The following information is provided in response to the information request given under section 12 of the Development Assessment Rules. The application is for a material change of use for Lot 31 Cape Tribulation Rd or otherwise known as 31RP740682.

Information Request Response Summary

PROJECT
Proposed Residence,
L31 RP740682,
Cape Tribulation Road,
KIMBERLEY

1 Site Plan
1 : 500

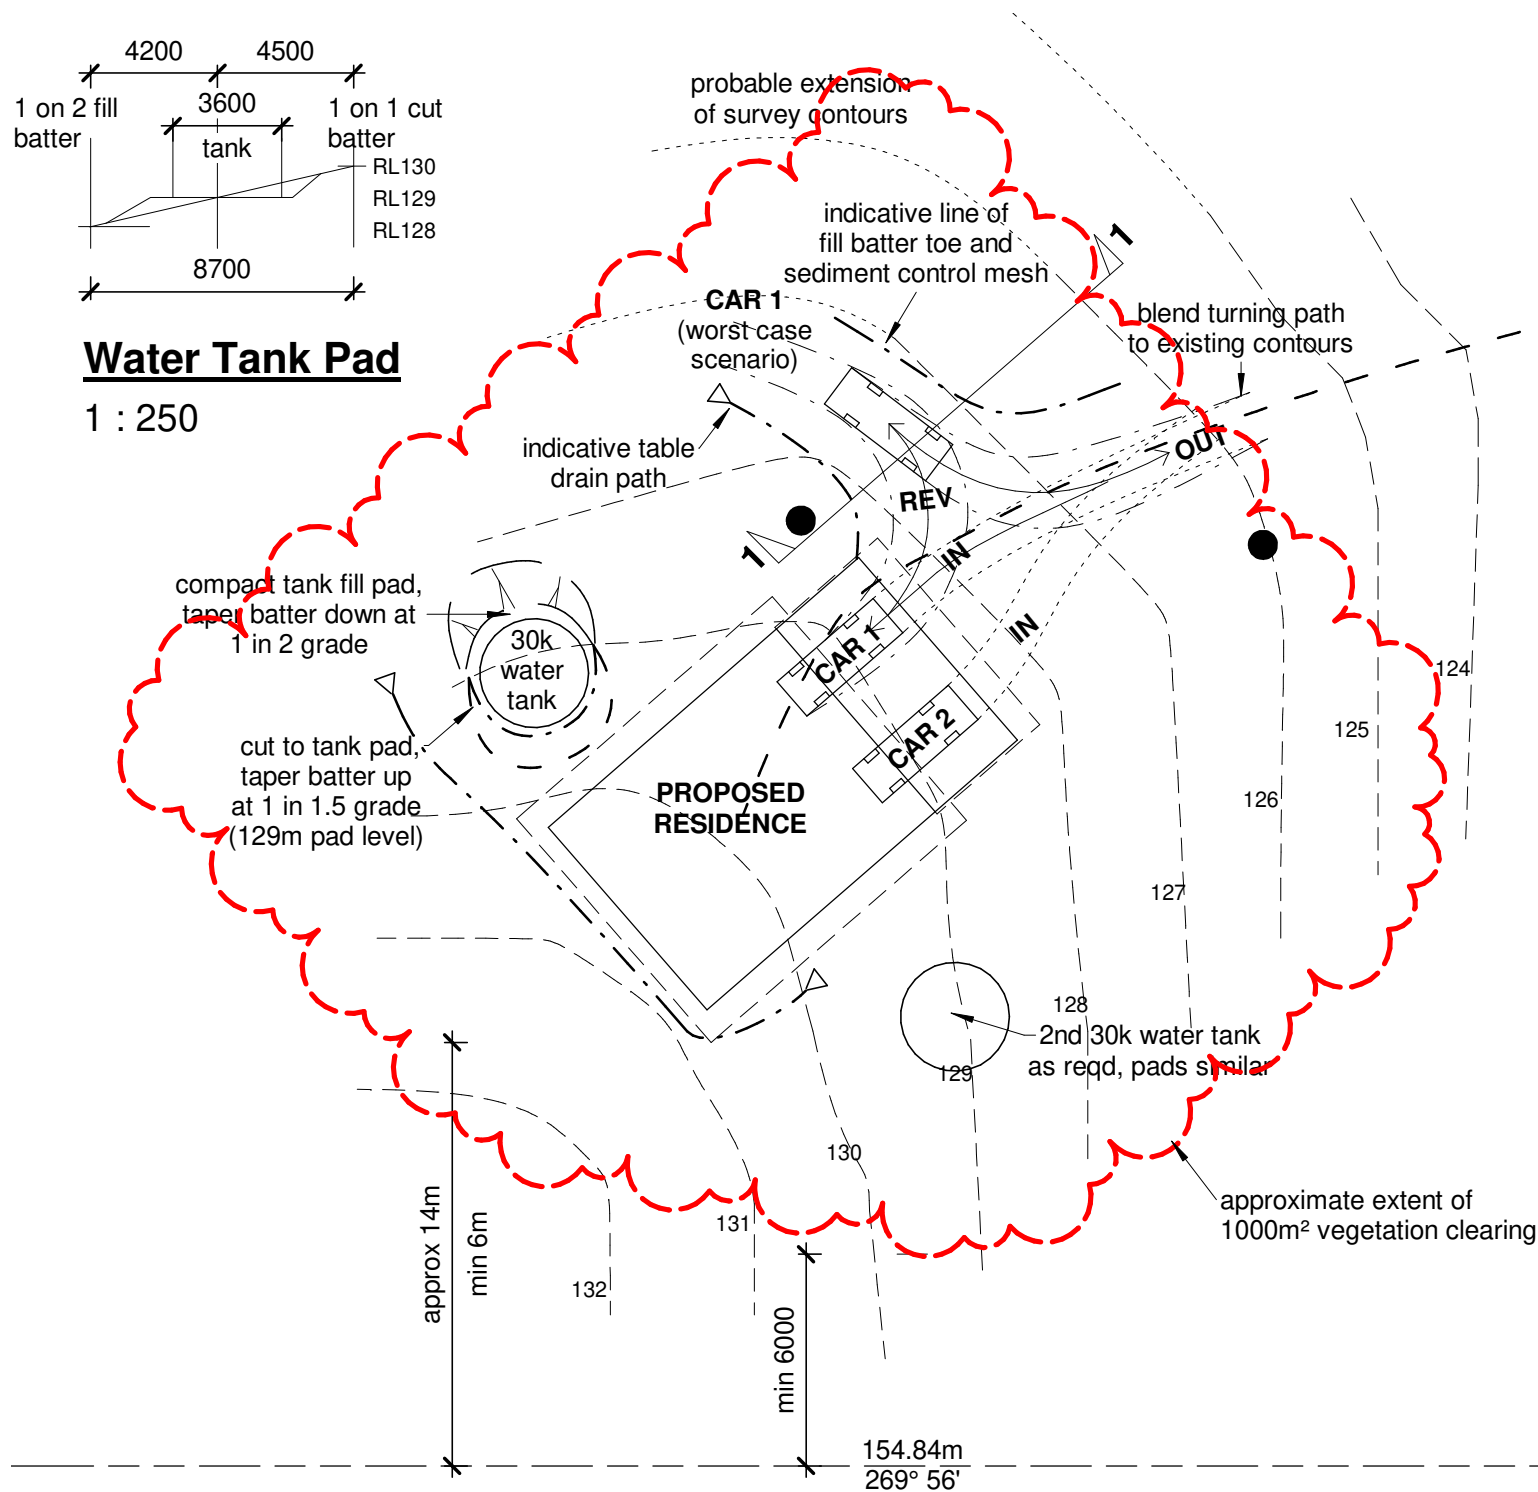
Provide a revised site plan detailing the proposed clearing around the house pad inclusive of the square metres required.

Provide a revised site plan detailing the location of the on-site effluent disposal system land application area and infrastructure.

Provide a revised site plan detailing the water tank location.

Provide a revised site plan detailing the vehicle parking and manoeuvring area to allow the vehicle to exit in the forward gear.

The clearing of vegetation has been depicted by the red cloud on the revised site plan and details the extent of clearing around the house pad. The extent of clearing is kept to the minimum required for the development.

The on-site effluent disposal system is identified on the revised site plan including the Septic Tank. The waste disposal area is marked and is laid parallel to the contours RL 127 and RL 126 corresponding with the Survey.

The water tank location is identified in the revised site plan and is placed to the north of the dwelling. The water tank is a total of 30L and is expected to be 3.6 metres in diameter.

The revised site plan includes the proposed vehicle parking and maneuvering area. The plan shows that the vehicle can exit in the forward gear and the turning path blends with the existing contours.

1 Part Site Plan
1 : 250

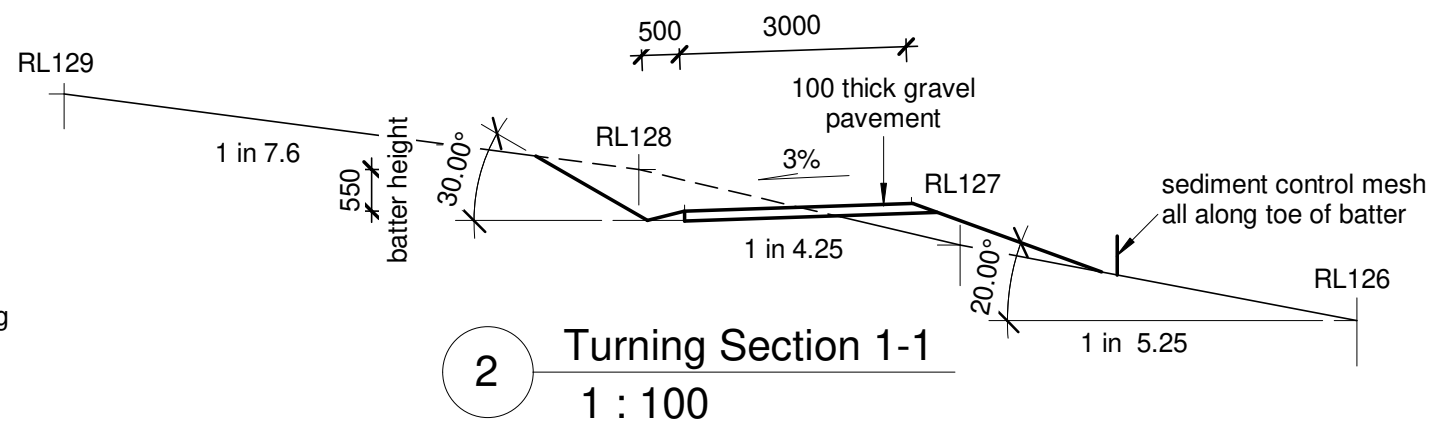
Provide an earthworks plan detailing the extent of cut and fill required to create a level pad around the house. The plan should detail; the height of cuts and batters.

Provide an earthworks plan detailing the extent of cut and fill required to create a level pad around the house. The plan should detail; The grade of cuts and batters and whether retaining is required.

Relevant earthworks have been provided to show the areas around the house where excavation is required. In all cases excavation is minimal and to the least extent possible for the development. The turning section has a batter height of 0.55 metres and the vehicle parking area has a batter height of 1.2 metres.

Relevant earthworks have been provided to show the areas around the house where excavation is required. The water tank has a 1 on 2 fill batter and a 1 on 1 cut batter. The vehicle parking area has a 1 on 2 cut batter. The turning section is 1 in 7.6 from RL 128 to RL 129 on the Survey and sediment control mesh is used all along the toe of the batter from RL 126 to RL 127 on the Survey.

1 North Elevation
1 : 100

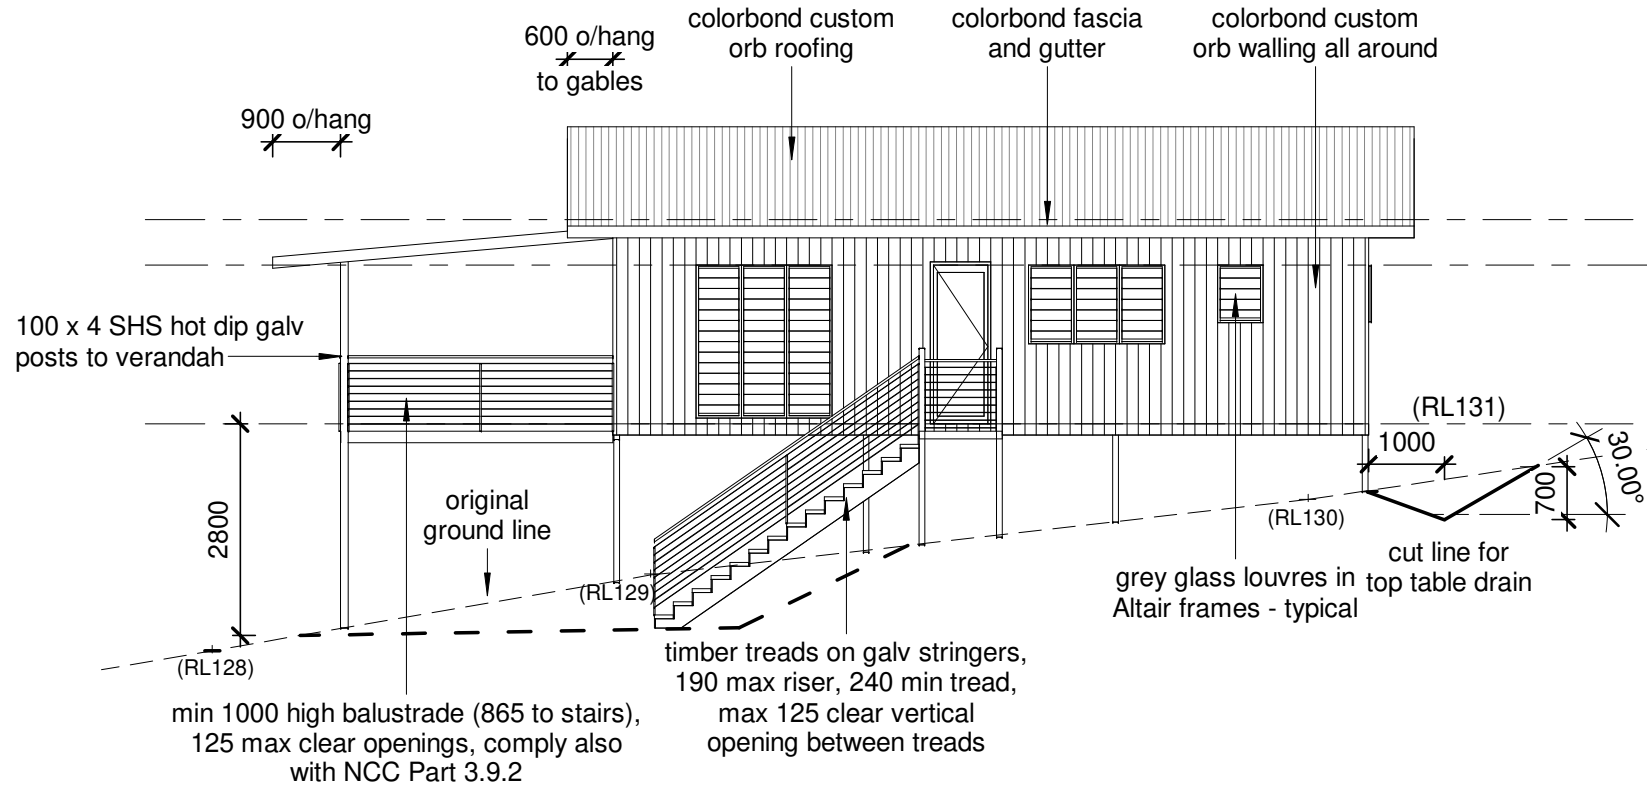
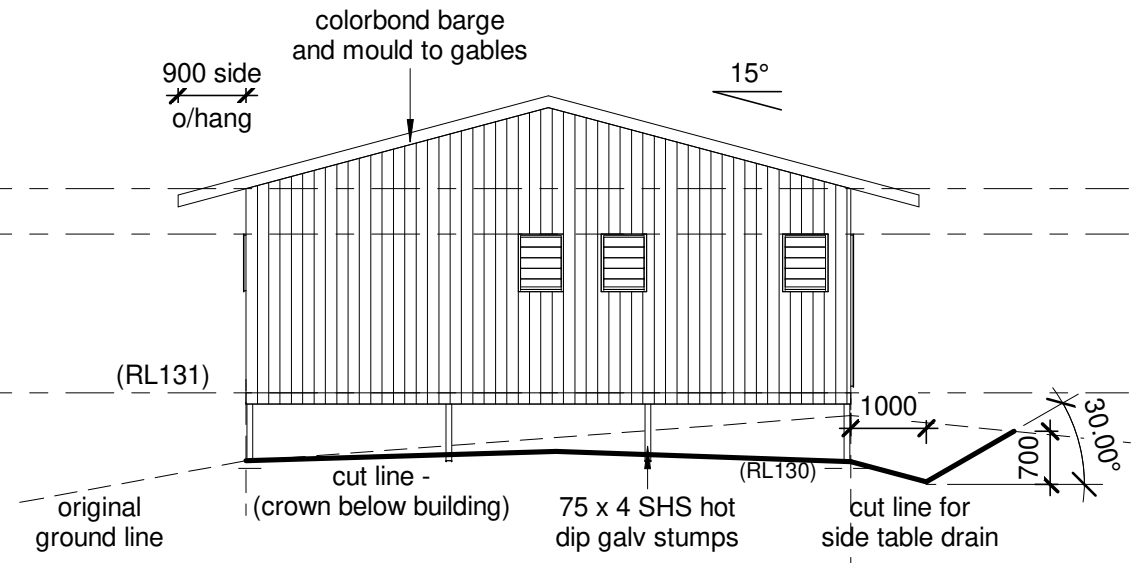
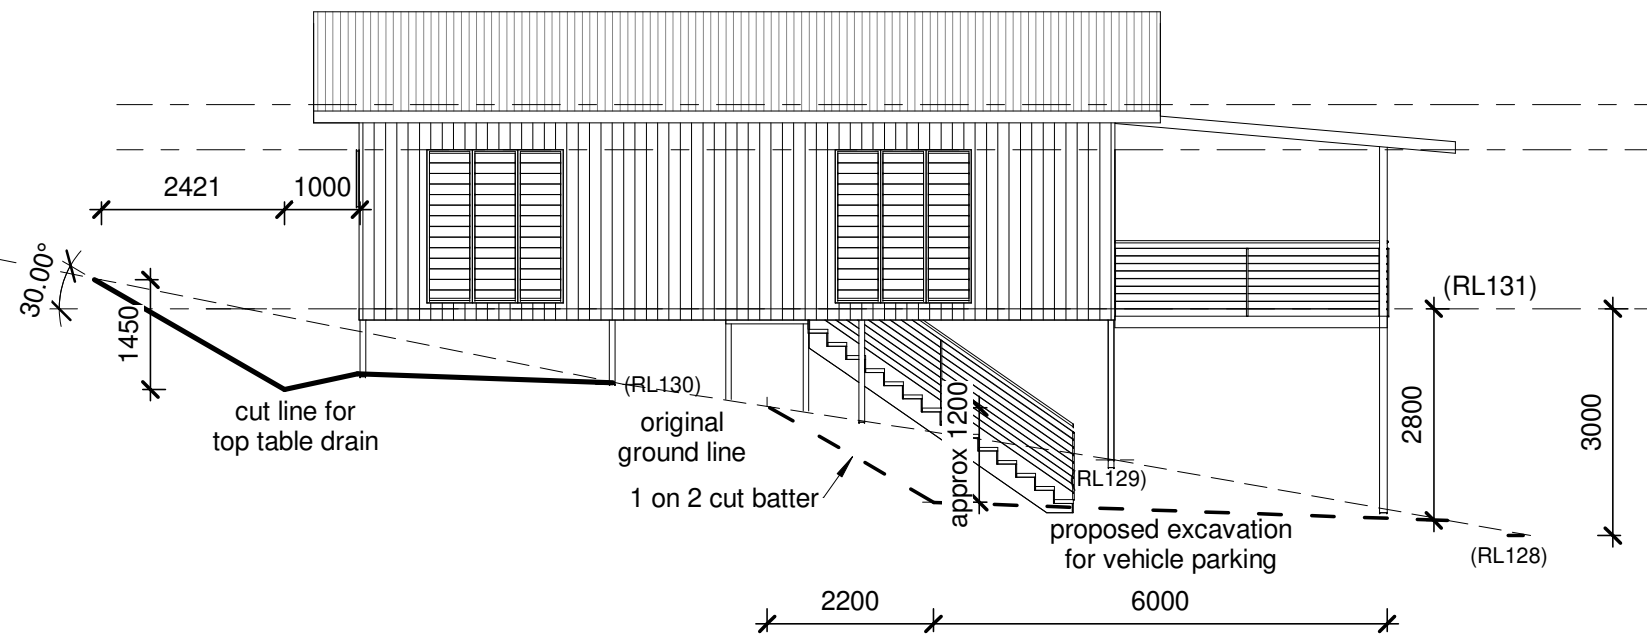
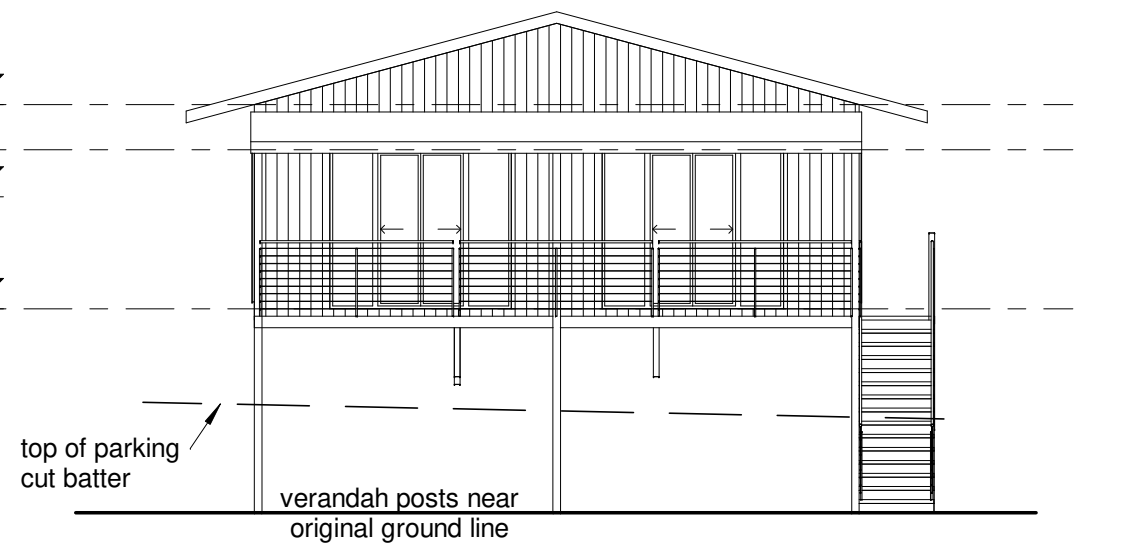
Provide an earthworks plan detailing the extent of cut and fill required to create a level pad around the house. The plan should detail drainage solutions.

Relevant earthworks have been provided to show the areas around the house where excavation is required. The cut line for the top table drain is located at RL 131 on the survey and is shown on the north and south elevation diagram. The side table drain is shown on the west elevation diagram.
